APPENDIX F GEOMORPHOLOGICAL REVIEW OF PAGODAS

Peer Review - Geomorphology of 'Pagodas'

As requested, please find herewith a peer review of information and conclusions contained within the report *Ecological Assessment for the Coalpac Consolidation Project* – *Contracted Project, Response to PAC Review Report (Final Report)*, referred to hereafter as the Response Report.

Figure 1 SPL (top) and Sandstone Outcrops (bottom) in the Ben Bullen State Forest

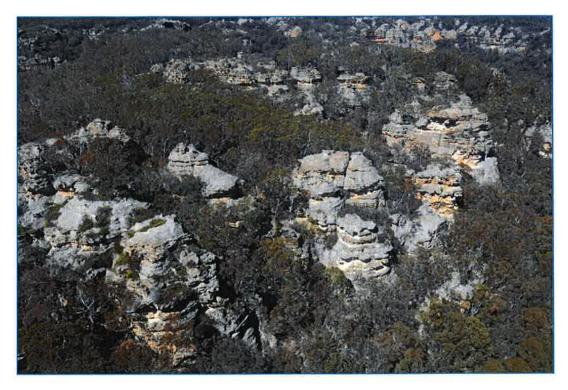
Figure 1 demonstrates the difference between an SPL and an area of Sandstone Outcrops (as defined in the Response Report) in the Ben Bullen State Forest. The SPL is a more striking and clearly-defined aggregation that exhibits a more varied and distinct morphology and variety of habitat types compared to the Sandstone
